RE: **Community Baptist Church**  
**3030 Todo Santos NW**  
**Grading Plan Stamp Date 3/6/20**  
**Hydrology File: G10D029J**

Based on the re-submittal received on 3/6/20, this project is approved for Building Permit. As a reminder, if the project total area of disturbance (including the staging area and any work within the adjacent Right-of-Way) is 1 acre or more, then an Erosion and Sediment Control (ESC) Plan and Owner's certified Notice of Intent (NOI) is required to be submitted to the Stormwater Quality Engineer (Doug Hughes, PE, [jhughes@cabq.gov](mailto:jhughes@cabq.gov), 924-3420) 14 days prior to any earth disturbance.

RE: Community Baptist Church, G10D029J

ENGINEER'S SEAL	Title: COMMUNITY BAPTIST CHURCH 3030 TODOS SANTOS NW GRADING AND DRAINAGE PLAN	DRAWN BY
		DATE
		DATE
		SHEET #
		1 of 1
		JOB #

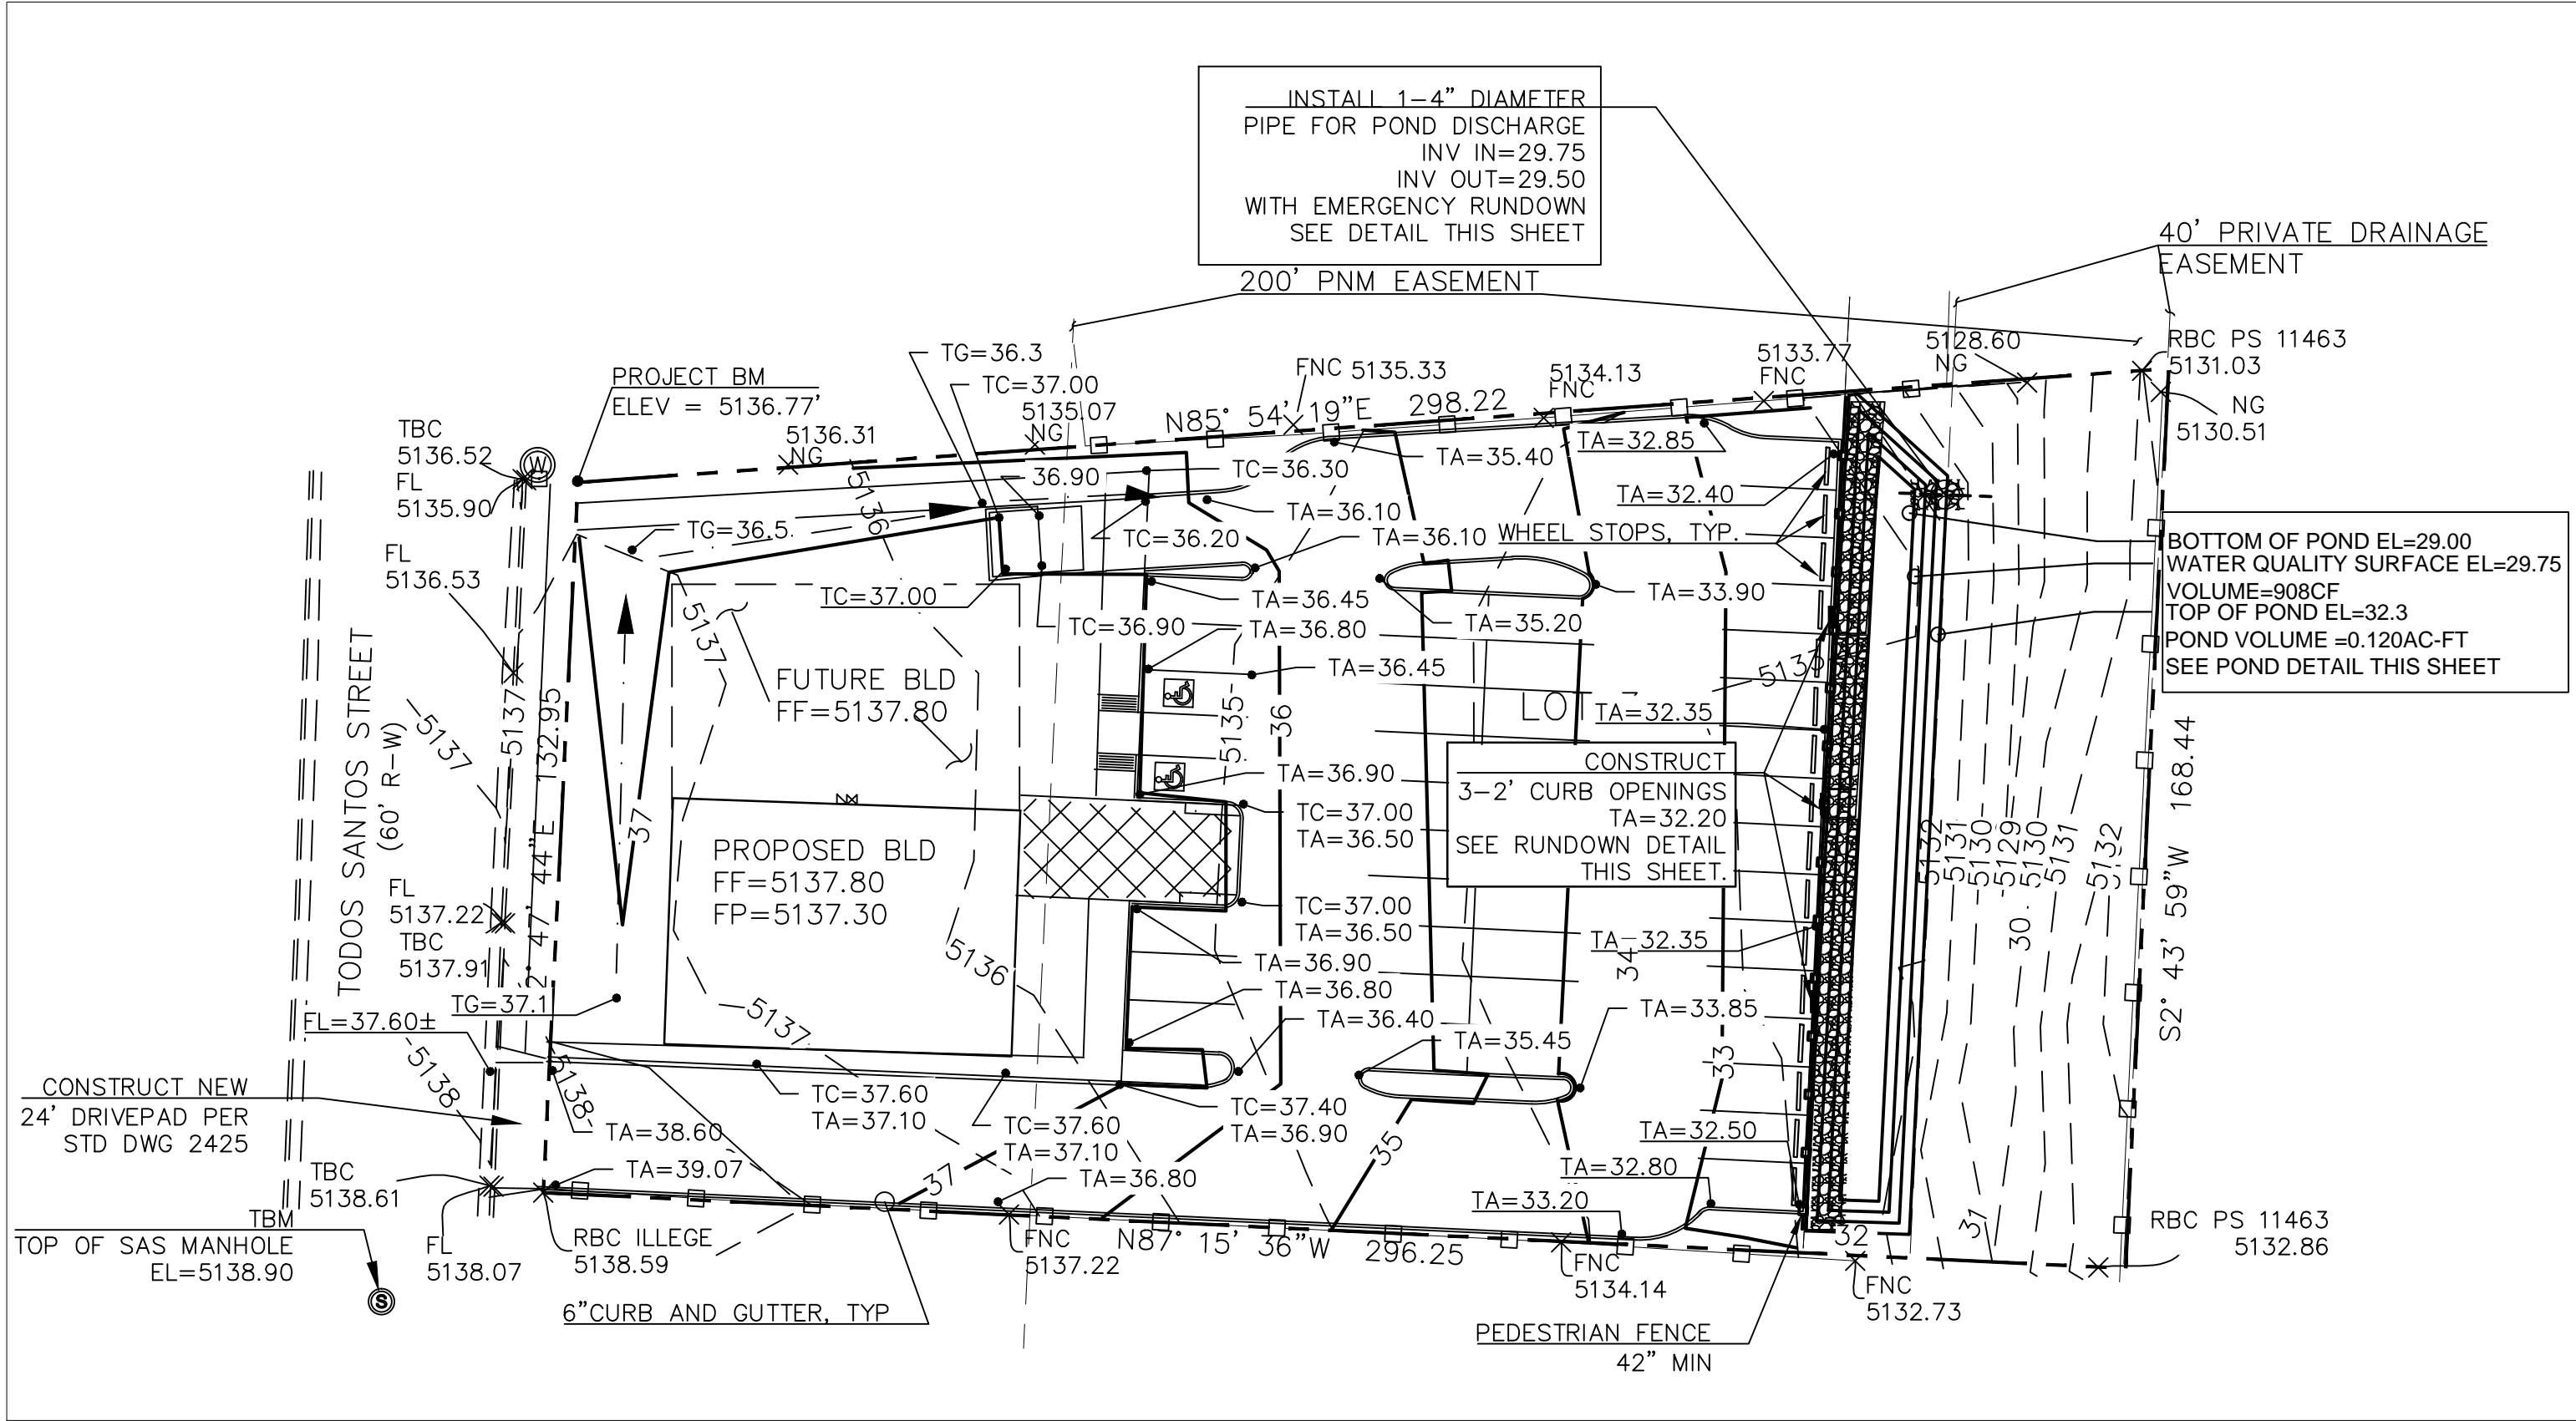
Thank you for your call regarding this site and the existing 40' Private Drainage Easement a few weeks ago. Pursuant to that conversation, the parking lot layout has been altered and the pond has been moved to the west, outside of the existing private drainage easement. I also revised the AHYMO -Appendix A for the new pond, this is also included in this submittal. The outfall for this site per our conversation was determined to be 0.43cfs per acre, with the new pond configuration this was achieved.

1. THE MASTER DRAINAGE PLAN FOR THIS AREA ALLOTS 0.43CFS PER ACRE DISCHARGE TO THE REAR OF THE LOT. THE EASTERNMOST 40' OF THIS LOT CONTAINS A DRAINAGE EASEMENT FOR THIS DISCHARGE. THE SITE IS 1.01ac, THUS THE SITE IS PERMITTED 0.43x1.01=0.43CFS DISCHARGE. THE PEAK DISCHARGE IS 0.393CFS (REFER TO SHEET 14 OF 15 – APPENDIX A).
2. THE STORM WATER QUALITY DISCHARGE REQUIREMENT IS 860CF, THE STORM WATER QUALITY POND PROVIDED IS 908CF, THE THE POND PROVIDED IS GREATER THAN THAT REQUIRED.
3. THE OUTFALL FOR THIS SITE WILL BE VIA A PIPE,  
THUS  $Q=CAsqt(2GH)$ ,  
WHERE  $Q=0.43CFS$   
 $C=0.60$   
 $G=32.2FT/S^2$   
 $H=2.0FT$   
THUS  $A=0.0619SF$  OR  $D=3.4"$ , USE A 4" PIPE.
4. THE MAXIMUM WSE FOR THIS DISCHARGE FOR THIS SITE IS 31.75 (REFER TO SHEET 15 OF 15 – APPENDIX A).
5. APPENDIX A CONTAINS THE COMPUTATIONS FOR THE STORMWATER DISCHARGE WITH RESPECT TO THIS SITE.
